A FIRST STAGE REPORT PREPARED FOR
EMPRESA DE ACUEDUCTO Y ALCANTARILLO DE BOGOTA ESP

STABILITY OF THE UPSTREAM SLOPE
OF THE
SAN RAFAEL DAM, BOGOTA

JANUARY 17TH 2000

FIGURA No. 11

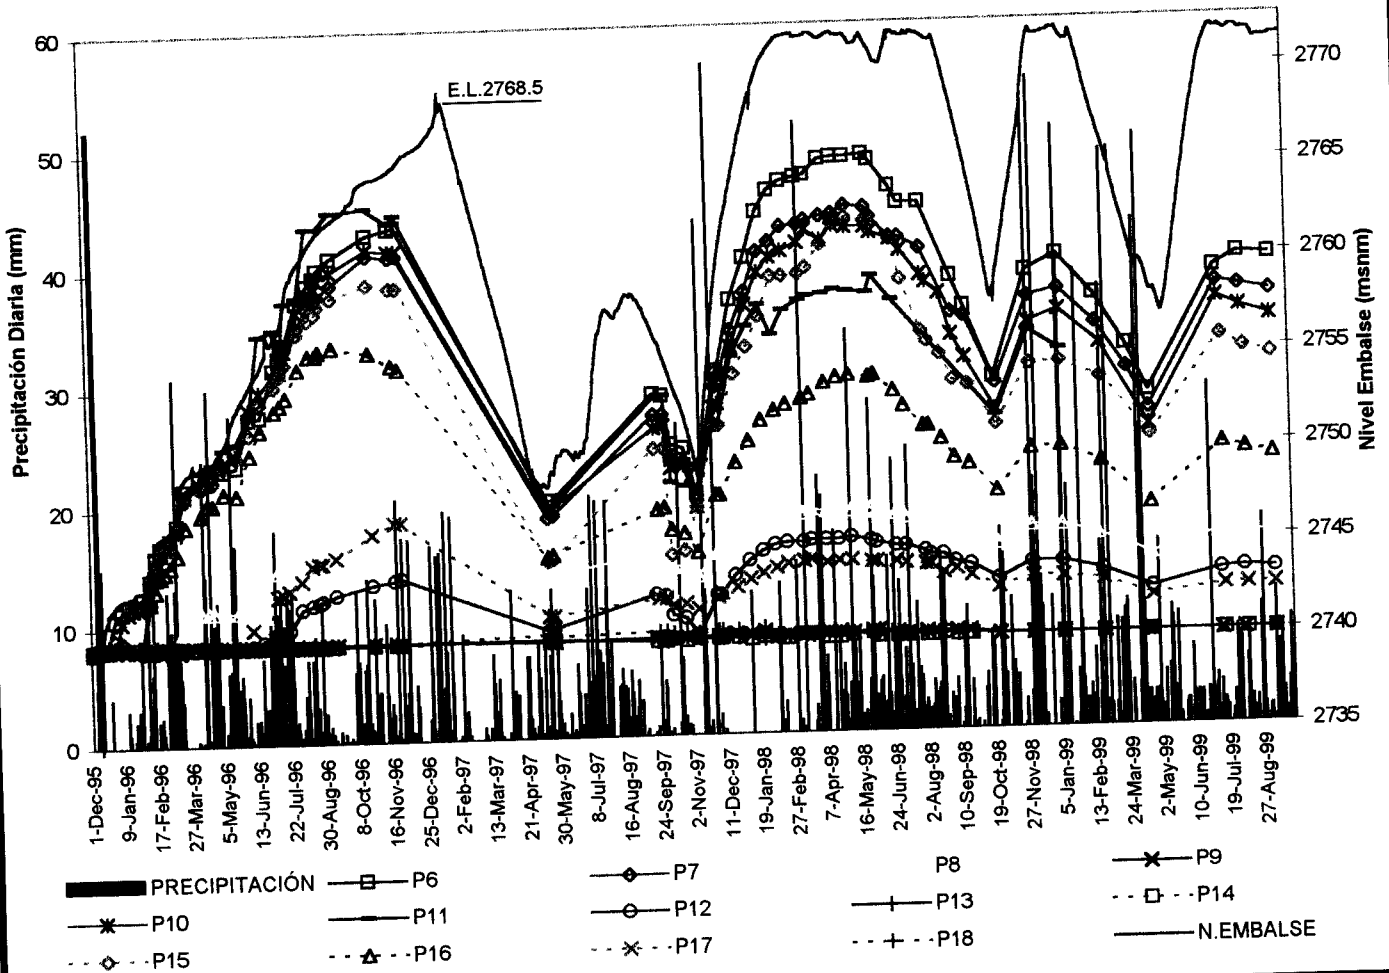
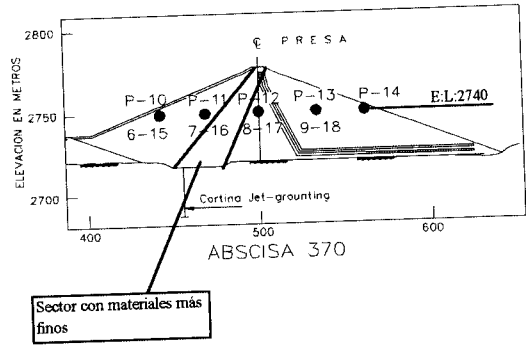
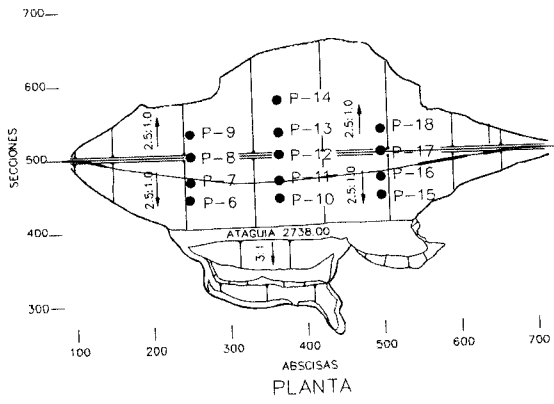
- 3.10 It is interesting to note that instability of the riprap was first noticed in the summer of 1997 following a drawdown of some 20 m over a period of about 4 months. (See Figure 11 of Documento CHSR-IM/004-044, dated September 1999 and entitled *Monitoreo del Comportamiento de las Estructuras Civiles de los Embalses de Chuza y San Rafael* which is reproduced here in Appendix B)

- 4.6 Results for piezometers P-10 and P-11, given in Figure 11 of Documento CHSR-IM/004-044 and reproduced here in Appendix B, suggest that drawdown of the phreatic surface in the Zone 1 fill is instantaneous and almost exactly follows drawdown of the impounded water level. This seems unlikely if the coefficient of permeability of the Zone 1 fill assumes the Ingetec S.A design value of 6×10^{-6} cm/s.

File: RANAI

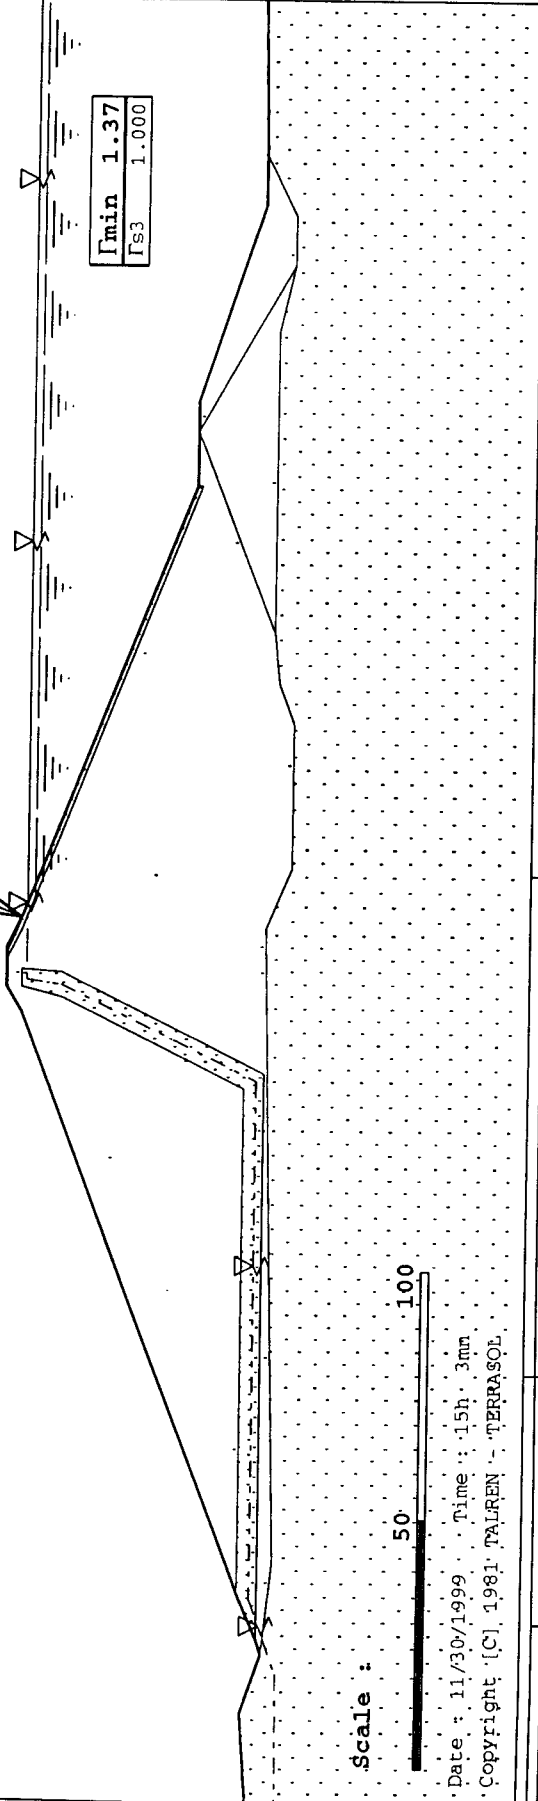
- 4.3 Talren file RANA1 considers rotational stability of the upstream slope, with water impounded to the maximum level of 2772.00, and returns a minimum detected calculated factor of safety of 1.37. The critical slip surface falls above the water line, on the 1:2.0 batter, so indicating calculated factors of safety greater than 1.37 below the impounded water level.

File: RANA2 Proj: SANRAPHA

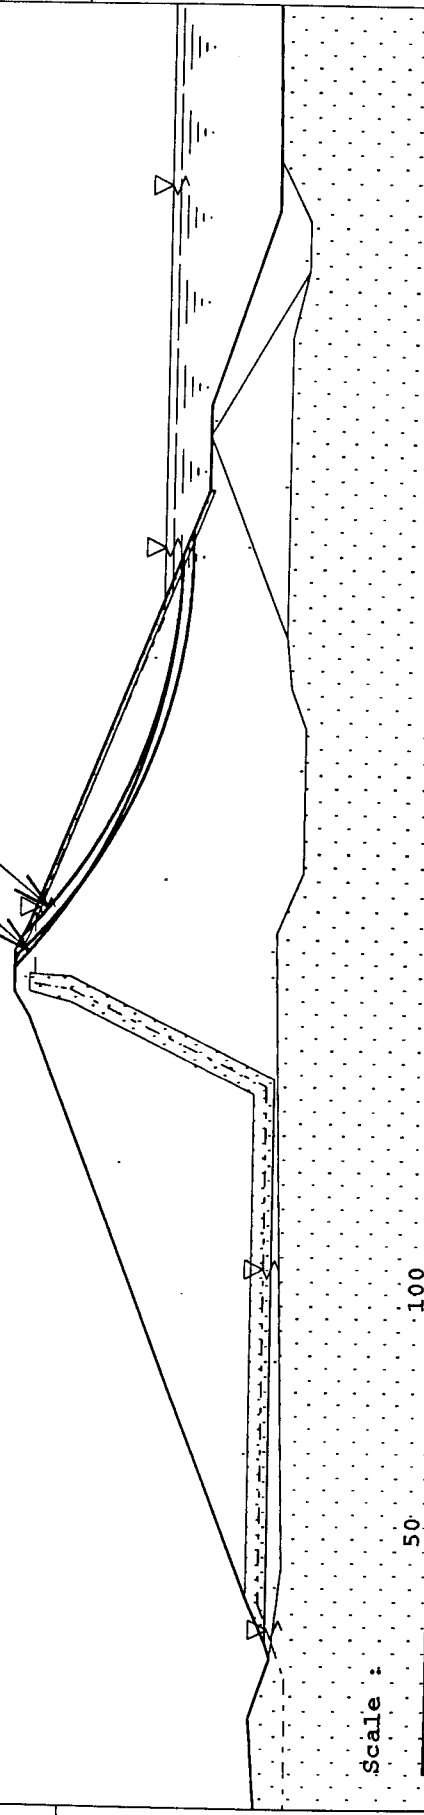
- 4.4 Talren file RANA2 considers rotational stability of the upstream slope with the impounded water level drawn down to a minimum recorded level of 2748.36. Based on the assumed Ingetec S.A Zone 1 fill ϕ' value of 32° and coefficient of permeability of 6×10^{-6} cm/s, the draw down is considered to be sudden and so the phreatic surface in the upstream slope, above a level of 2748.36, is considered to lay immediately below the riprap. These assumptions lead to a minimum detected calculated factor of safety of 0.91 which implies failure.

- 4.5 Clearly, no such failure has occurred and this suggests that either the phreatic surface within the Zone 1 fill is drawn down in sympathy with the impounded water level and/or the actual ϕ' value is greater than

- 4.7 With any piezometer system there is a finite lag time between the recorded and true piezometric level. Consequently, actual phreatic levels tend to be higher than recorded levels. So, for design, it is prudent to assume a high phreatic surface associated with sudden drawdown as is the case in Talren file RANA2.

STATIC ANALYSIS OF UPSTREAM SLOPE
 MINIMUM RECORDED WATER LEVEL 2748.36
 RAPID DRAWDOWN SCALE 1:1500
 File: RANA2A Proj: SANRAPHA

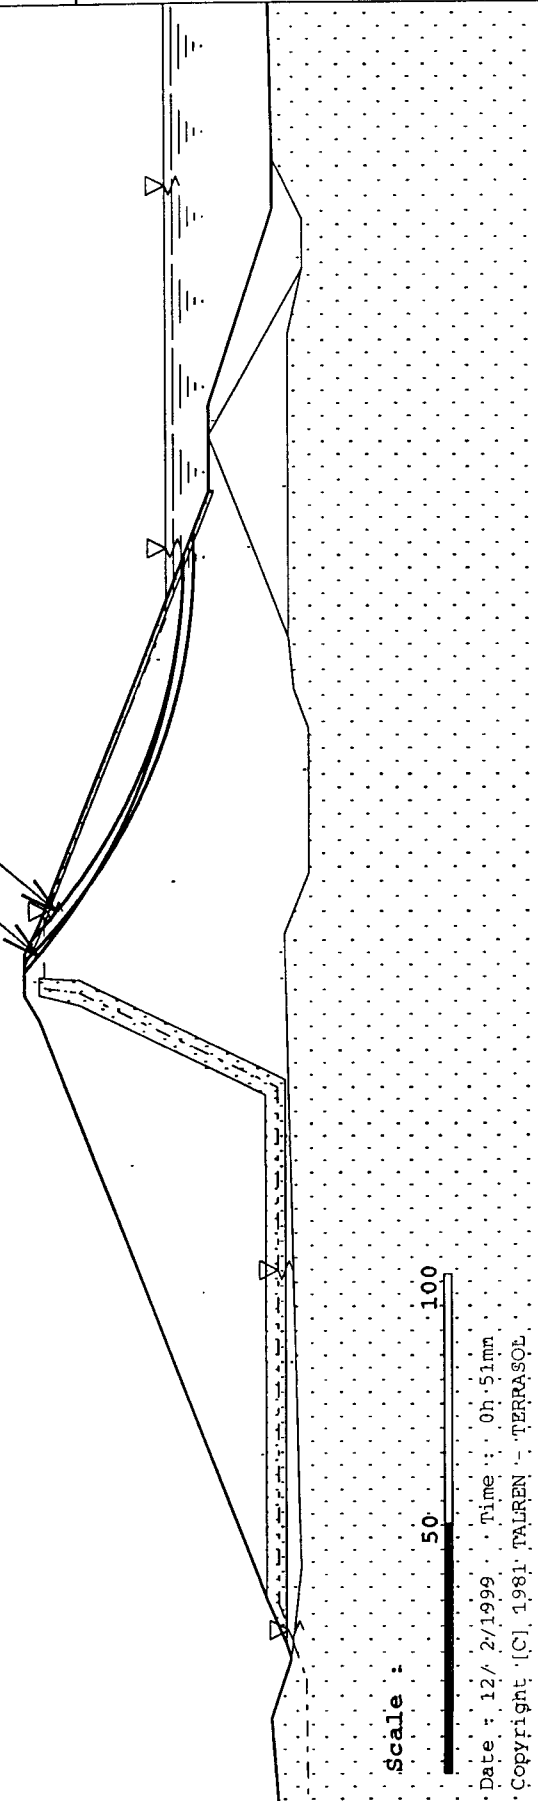
- 4.10 Like Talren file RANA2, Talren file RANA2A considers rotational stability of the upstream slope with the impounded water level drawn down to a minimum recorded level of 2748.36 and a phreatic surface in the upstream slope immediately below the riprap. However, in RANA2A the ϕ' value has been increased by 3° from 32° to 35°. The effect of this small increment in ϕ' is to increase the calculated factor of safety from 0.91 to 1.02 so demonstrating the sensitivity of calculated stability to small changes in ϕ' .

STATIC ANALYSIS OF UPSTREAM SLOPE
 MINIMUM RECORDED WATER LEVEL 2748.36
 DRAWDOWN PER PIEZO P10 & 11 SCALE 1:1500
 File: RANA3 Proj: SANRAPHA

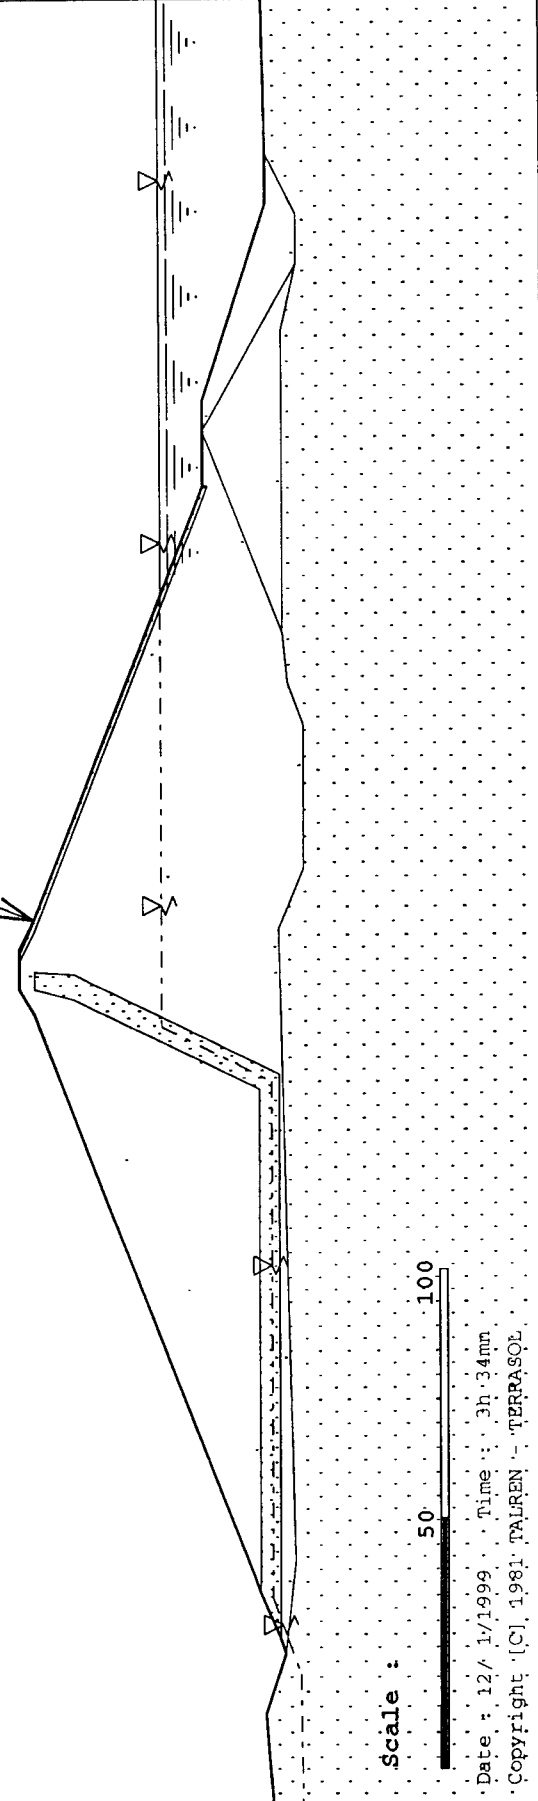
- 4.11 Talren file RANA3 again considers rotational stability of the upstream slope with the impounded water level drawn down to a minimum recorded level of 2748.36 but in this analysis the phreatic surface

within the upstream shoulder of the dam is also assumed to be drawn down to a level of 2748.36. As expected, these assumptions lead to a minimum detected calculated factor of safety of 1.37 with the critical slip surface falling near the crest of the dam where the slope batter increases to 1:2.0.
